29 May 2020
Ref: 17/0372/L1

78 Holmes Road (planning reference 2017/3789/P)
Acoustic Barrier Review

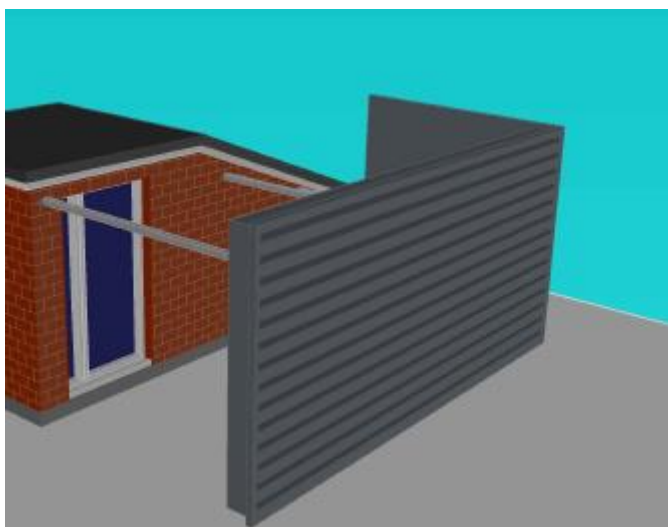
Cole Jarman have previously undertaken a plant noise assessment for the site at 79 Holmes Road, London (ref. 17/0372/R02-0). As part of the mitigation strategy a new 2.5m acoustic barrier was recommended to the plant zone as marked up in red below:

This barrier was initially stated to need to be solid and imperforate with no holes or gaps so to not compromise its effectiveness as a noise mitigation measure.

Conversely the barrier that has been installed on site is of the following layout, still at 2.5m in height but utilising an acoustic louvre and not including the panel on the eastern side. The image shown is from the north-east direction.

With the on-site louvre in place, the noise limits are calculated to be achieved at the assessment positions and therefore the installed mitigation is appropriate.
